Grimes Planning and Zoning Commission

Planning and Zoning Commission May 2, 2023 @ 5:30 p.m. **In Person at Grimes Community Complex, 410 SE Main Street, Room 202**

The Development Services Department is in receipt of a proposed Site Plan for the Green State Credit Union. Based on the review of the provided submittal materials, staff have the following comments:

UTILITY PLAN

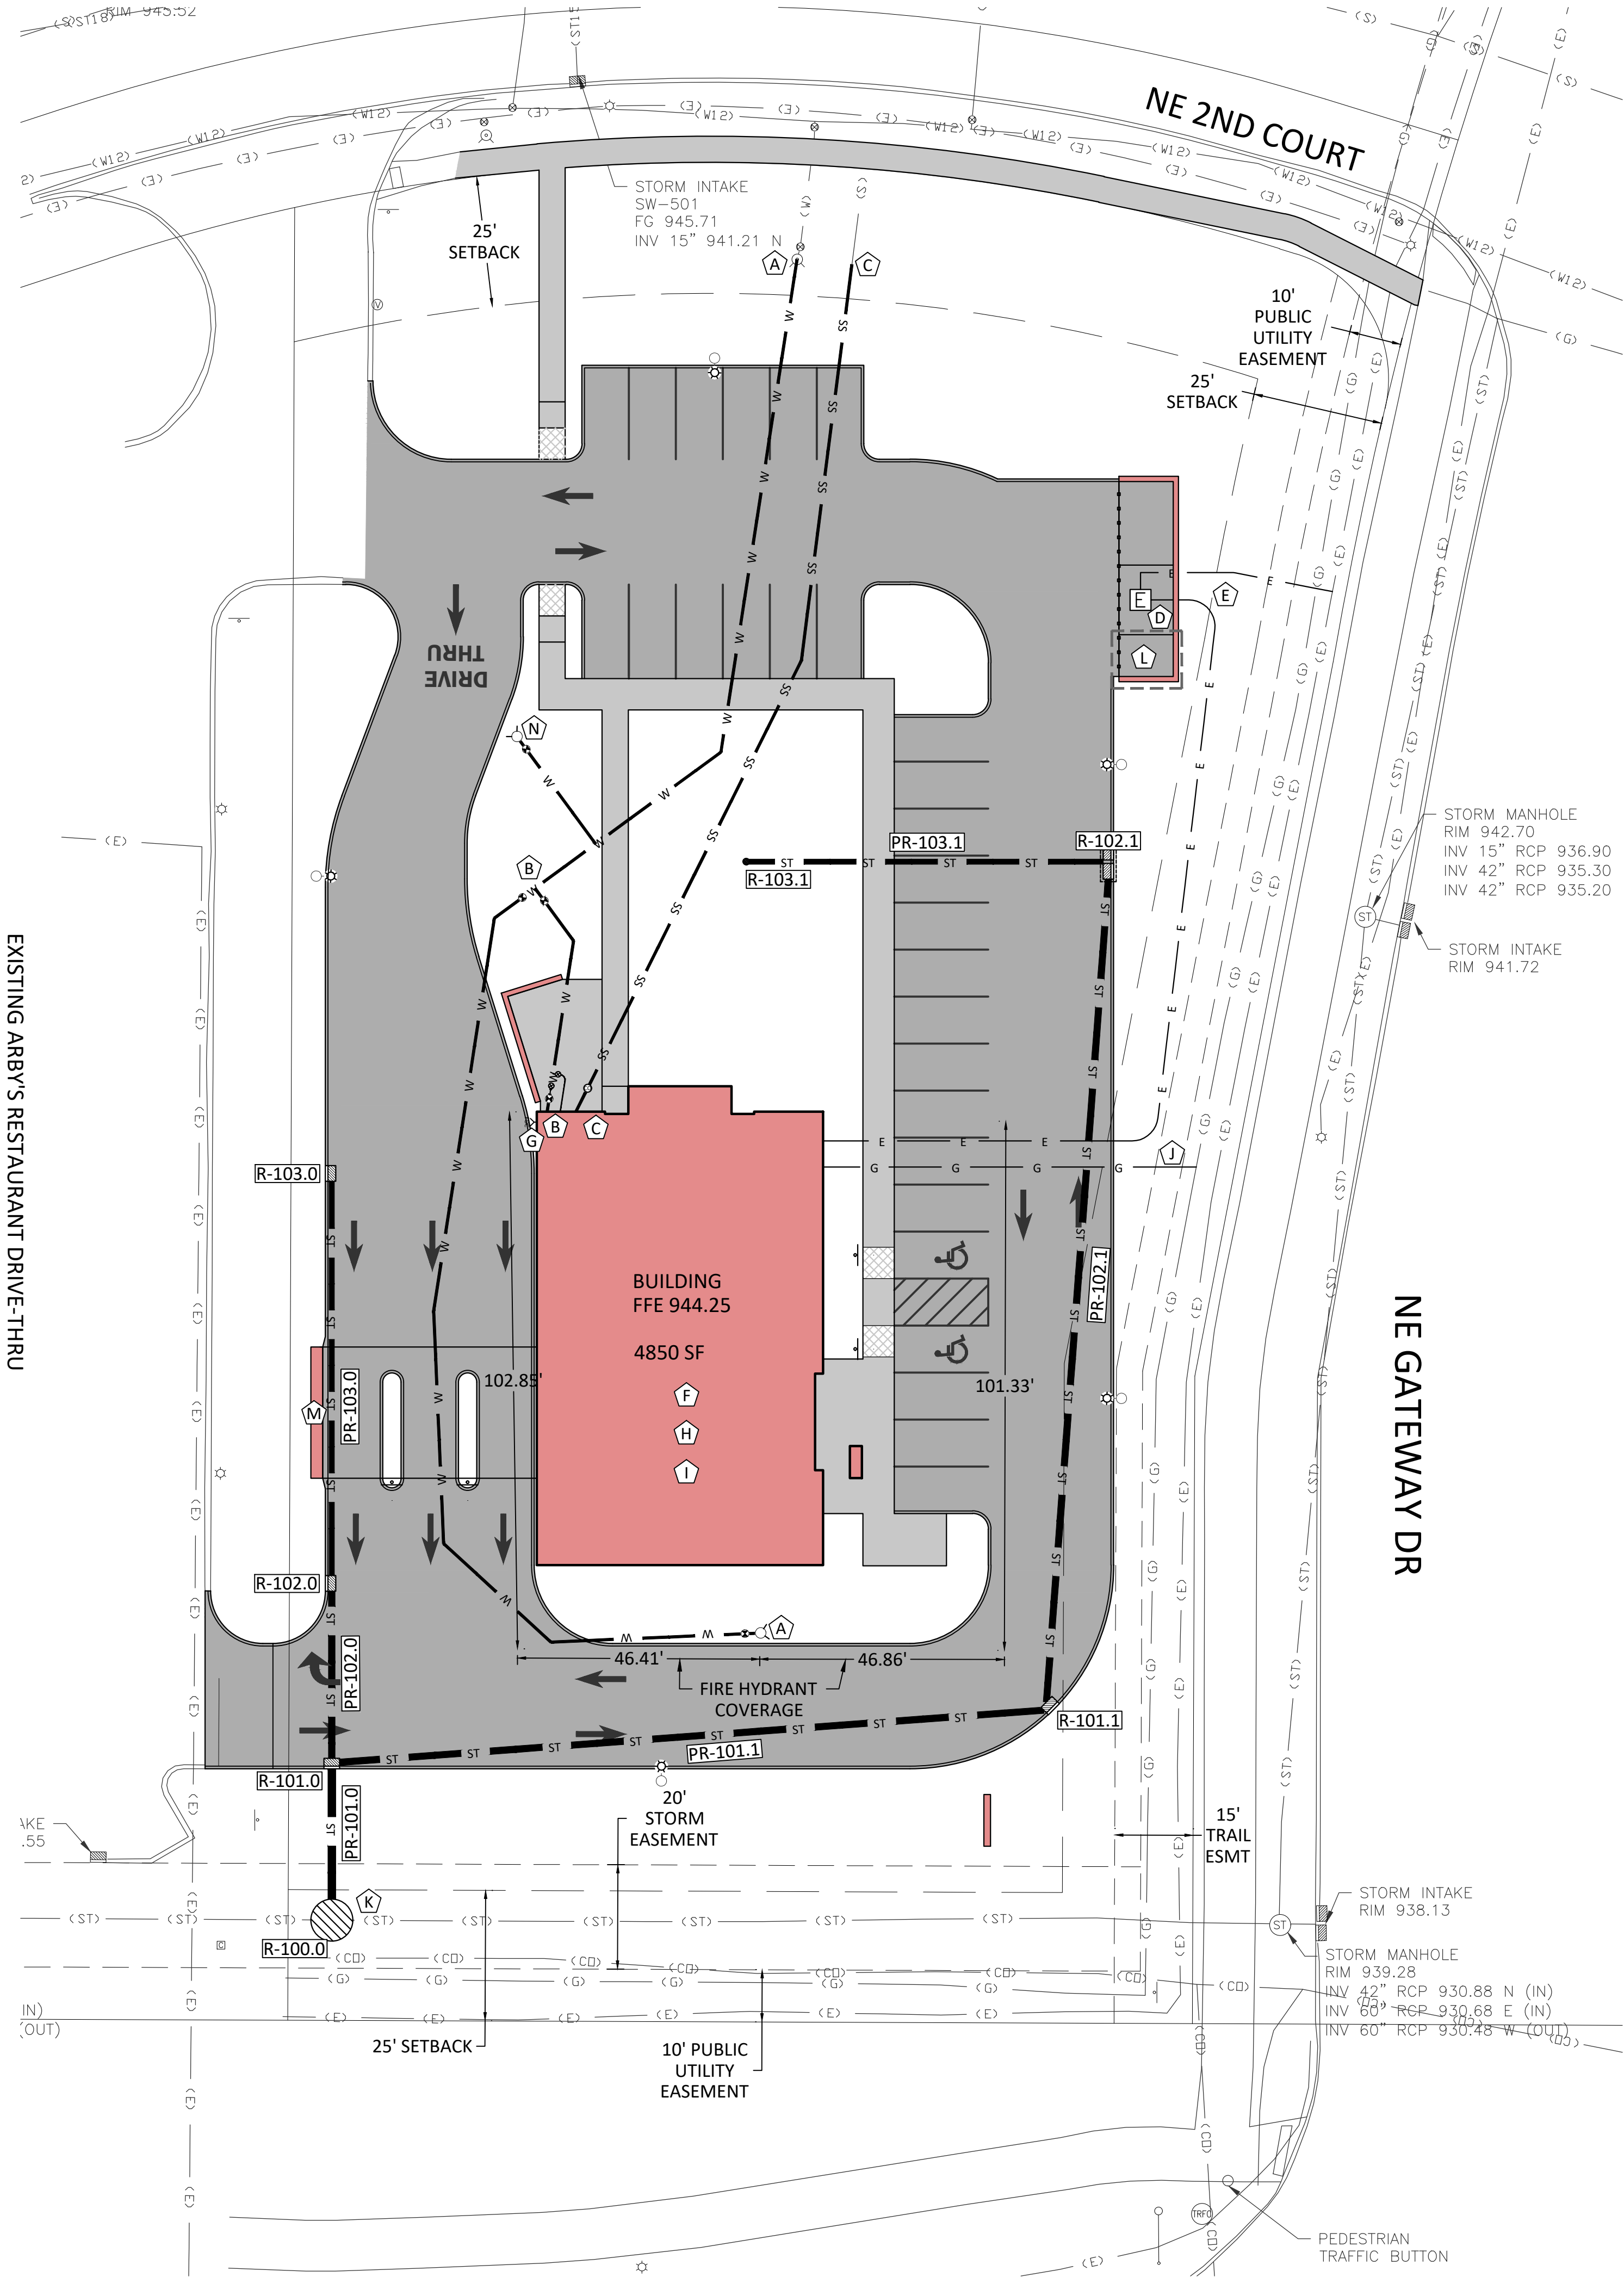
7. Please place a hydrant on the north side of the building, within 100' of the FDC. This will provide hydrant coverage for the north side of the building.

REMOVE EXISTING HYDRANT AND CONNECT TO EXISTING WATER MAIN. INSTALL ±338 LF (EXISTING STUB TO PROPOSED SOUTH HYDRANT) OF 6" C900 PVC WATER MAIN. WATER MAIN TO BE INSTALLED PER CITY OF GRIMES WATER MAIN STANDARDS, PROVIDE MINIMUM 5.5' BURY. CONTRACTOR TO PROVIDE WATER MAIN FITTINGS AS NECESSARY TO ROUTE PROPOSED 6" WATER MAIN FROM EXISTING STUB TO HYDRANT.

PROPOSED 6"x6" MJ TEE AND ±25 LF (TEE TO NORTH HYDRANT) OF 6" C900 PVC WATER MAIN. WATER MAIN TO BE INSTALLED PER CITY OF GRIMES WATER MAIN STANDARDS, PROVIDE MINIMUM 5.5' BURY.

PAVEMENT AND GRADING PLAN

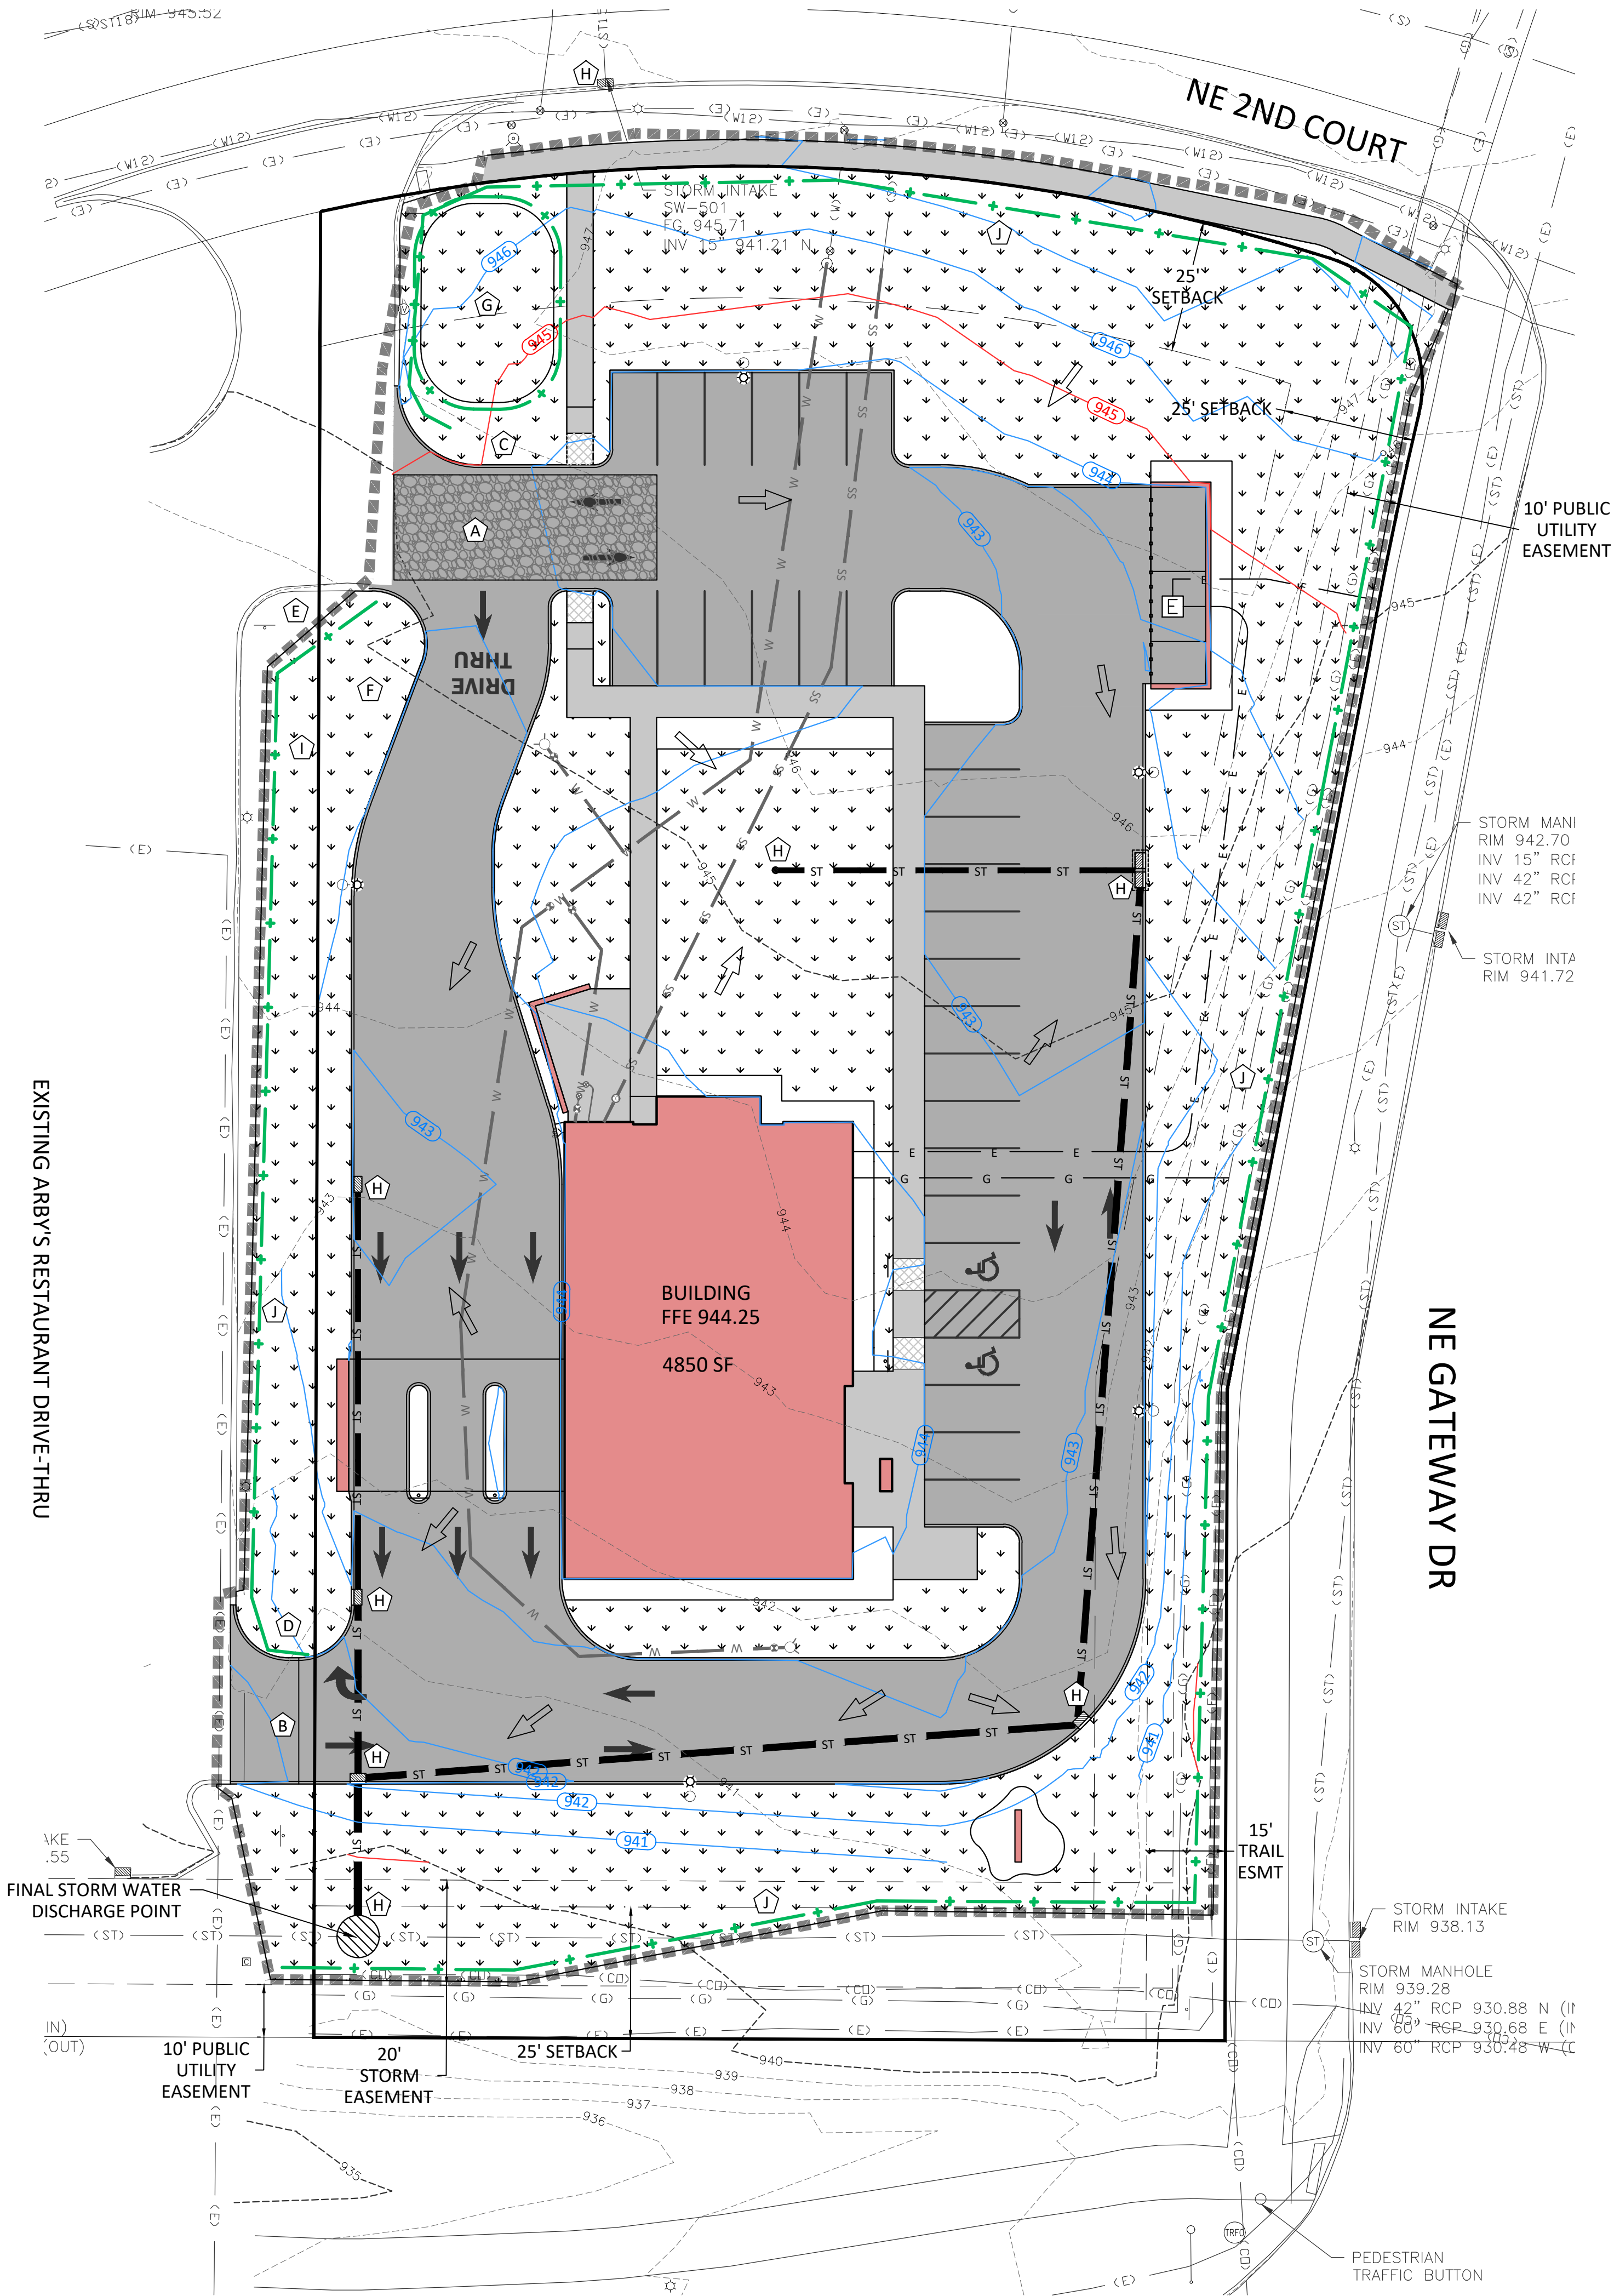
- ~~1. Please call out to remove and replace sidewalk along NE Gateway Drive for storm sewer connection. The trail closure will need to be coordinated with the city and be poured back within 48 hours. The connection to the existing structure will need to be made with core drill.~~

K) REMOVE AND REPLACE ± 80 SF OF EXISTING SIDEWALK FOR STORM CONNECTION. THE TRAIL CLOSURE WILL NEED TO BE COORDINATED WITH THE CITY AND BE POURED BACK WITHIN 48 HOURS.

STAFF AREA DETAIL

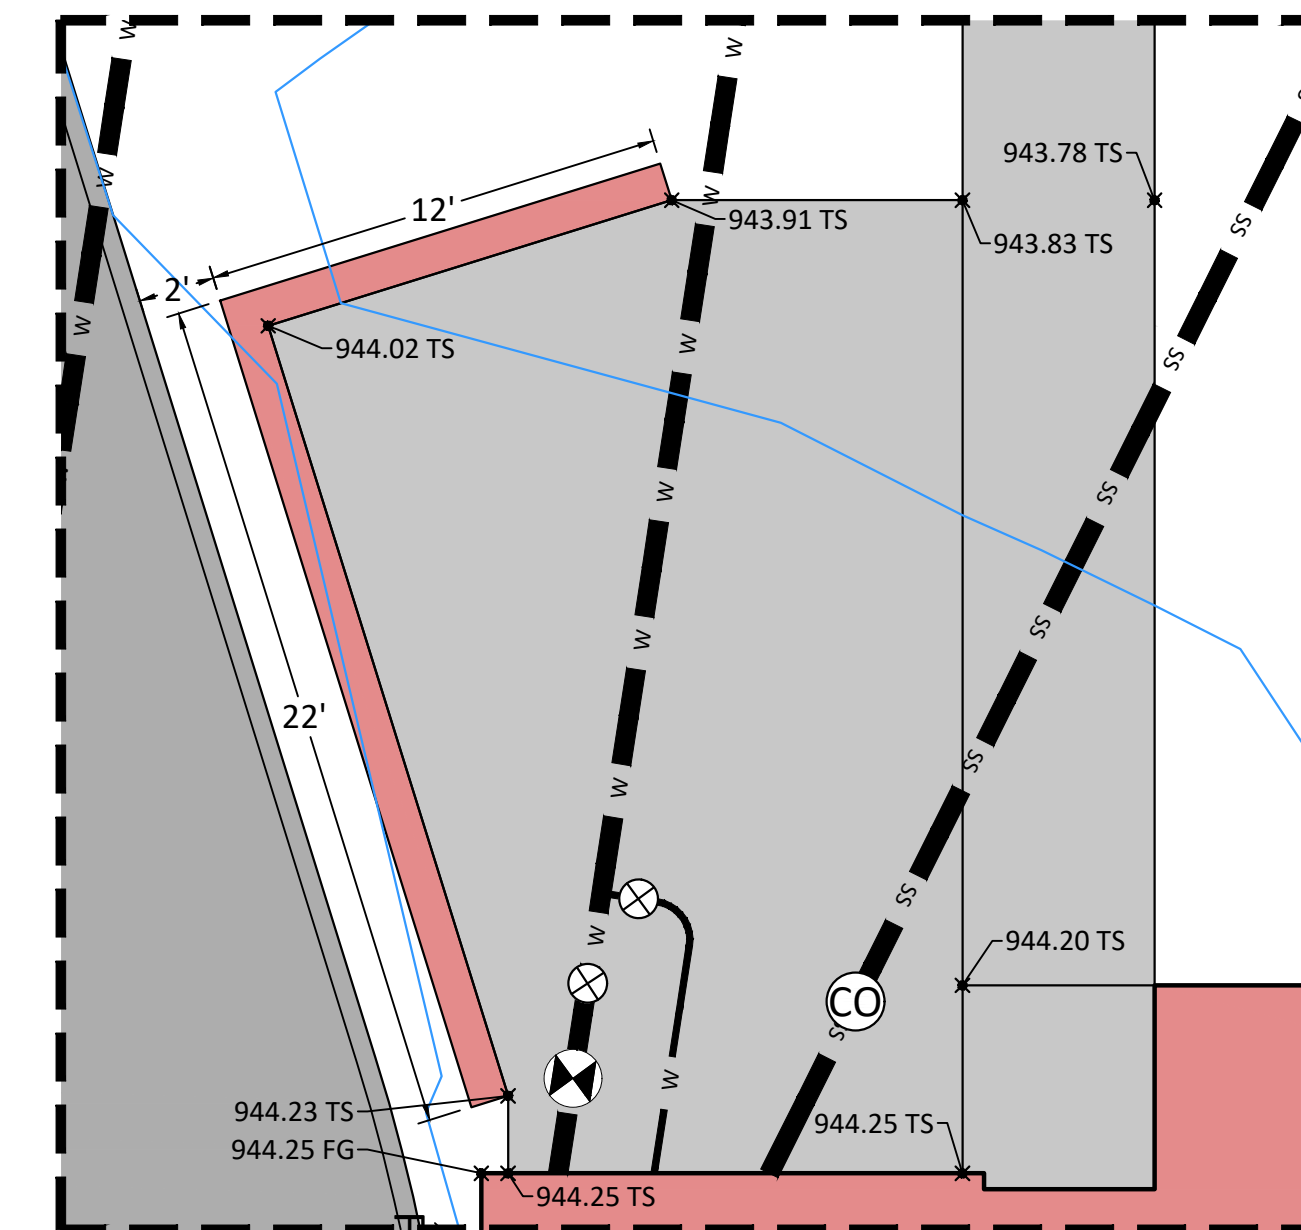
- ~~1. Please revise grades within Staff Area Detail 11 to allow water to drain.~~

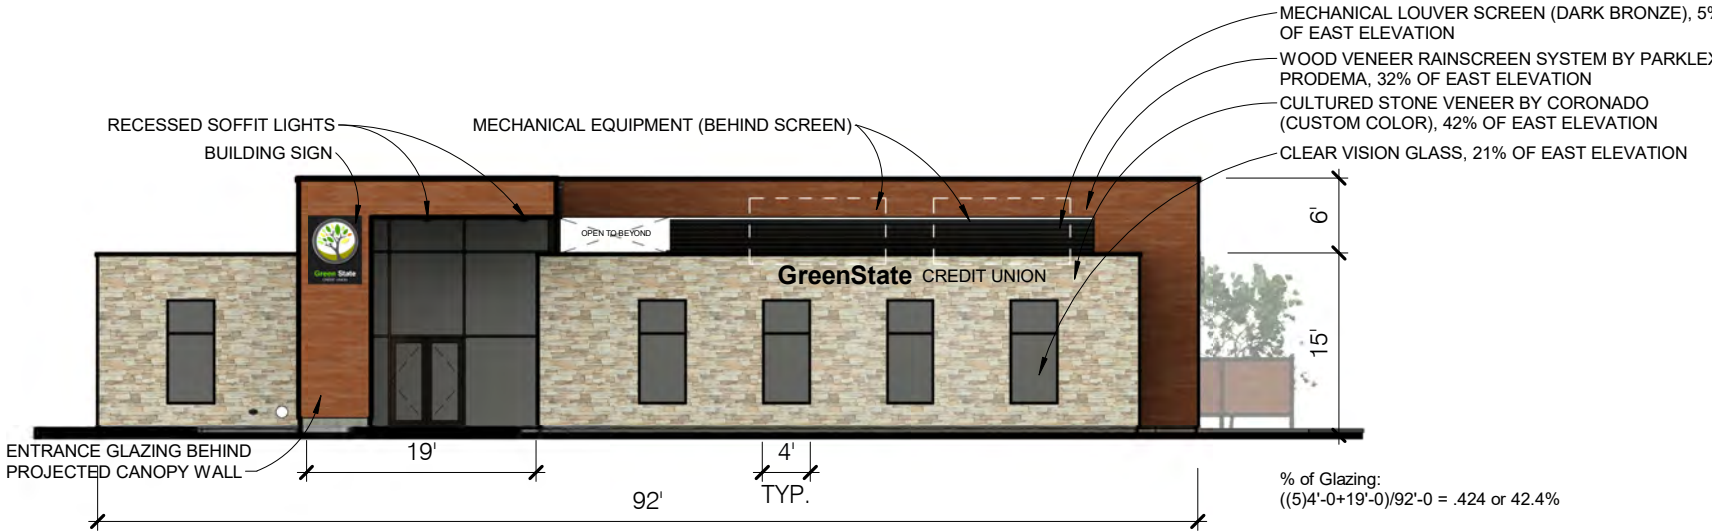
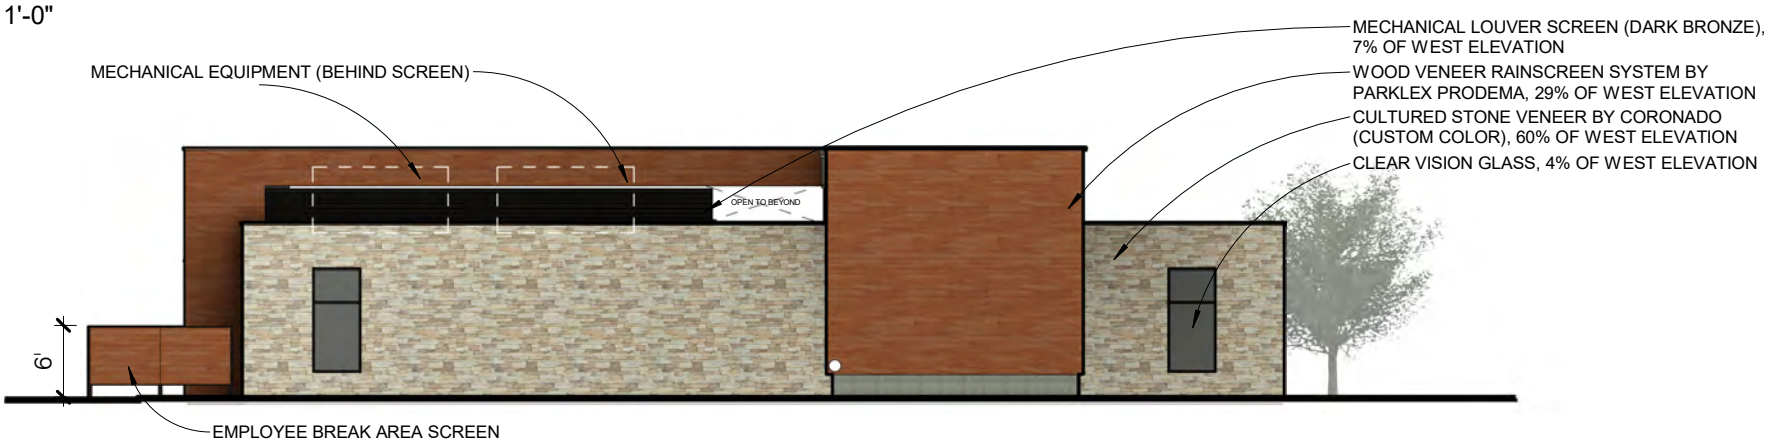
1. Please provide elevations for dumpster enclosure, including its materials. Gates are required to be opaque and metal-framed. Please label and revise material.

- ~~2. It looks like part of the dumpster enclosure is shown in the South elevation. This is not how it is laid out on the site plan. Please remove/adjust.~~

9. Label electrical and mechanical equipment on the elevations. Roof-mounted equipment needs to be screened with parapet wall or point in place screening. Ground-mounted equipment needs to be screened from public streets with fencing or evergreen plantings.

10. Is lighting proposed on the building? Please provide locations and lighting cut sheets.
